Access Compliance Report

Public Rights-of-Way

(Curb Ramps)

Intersection ID: 13871	Main Street: E_5TH_ST	Cross Street: HAWTHORNE_LN	Location: E
ADA ID: 54BD2460C42D	Ramp Type: PerpDiag	Initial Pass/Fail: Fail	Overall Compliance: No
Severity Score: 12.5			
Codes/Mitigation Info/Possible Solution		Field Measurements/Component Compliance

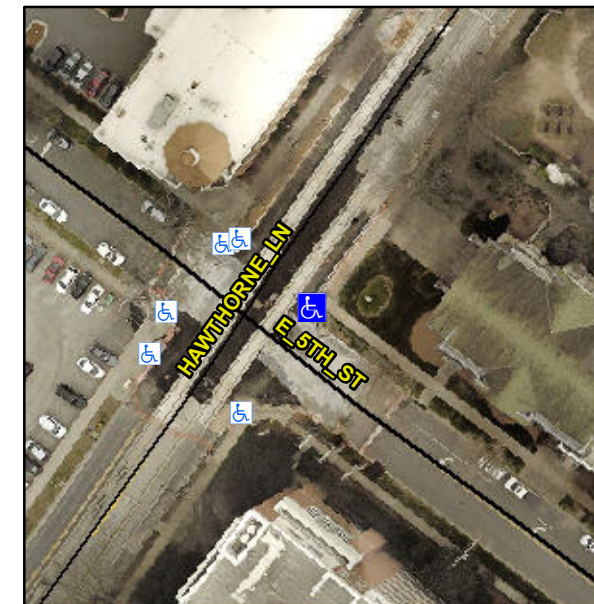
Not Found, R304.2.2

Compliance	Description	Data	Compliance	Description	Data
N/A	Ramp Length (in)	59.0	No	Ramp Slope (%)	8.9
Yes	Ramp Width (in)	48.0	Yes	Ramp XSlope (%)	1.1
N/A	Flare Type LT	N/A	N/A	Flare Type RT	N/A
N/A	Flare Slope LT (%)	N/A	N/A	Flare Slope RT (%)	N/A
N/A	Flare Traversable LT?	N/A	N/A	Flare Traversable RT?	N/A
N/A	Landing Length (in)	N/A	N/A	DWS Provided?	N/A
N/A	Landing Width (in)	N/A	N/A	DWS Contrast?	N/A
N/A	Landing Slope (%)	N/A	N/A	DWS Length (in)	N/A
N/A	Landing X Slope (%)	N/A	N/A	DWS Full Width?	N/A
N/A	Landing Curb? (Y/N)	N/A	N/A	DWS Offset (in)	N/A
N/A	Shared Landing?	N/A			
N/A	Gutter Ponding?	N/A	N/A	Gutter Slope (%)	N/A
N/A	Gutter Lip Ht (in)	N/A	N/A	Gutter X Slope (%)	N/A
N/A	Painted X Walk1?	Yes	N/A	Painted X Walk2?	Yes
	X Walk 1 Direction	To NW		X Walk 2 Direction	To SW
N/A	X Walk 1 Width (in)	139.0	N/A	X Walk 2 Width (in)	112.0
	X Walk 1 Slope (%)	4.9		X Walk 2 Slope (%)	8.5
	X Walk 1 X Slope (%)	3.9		X Walk 2 X Slope (%)	4.2

Remove & Replace Curb Ramp With Two New Directional Ramps or Equivalent.
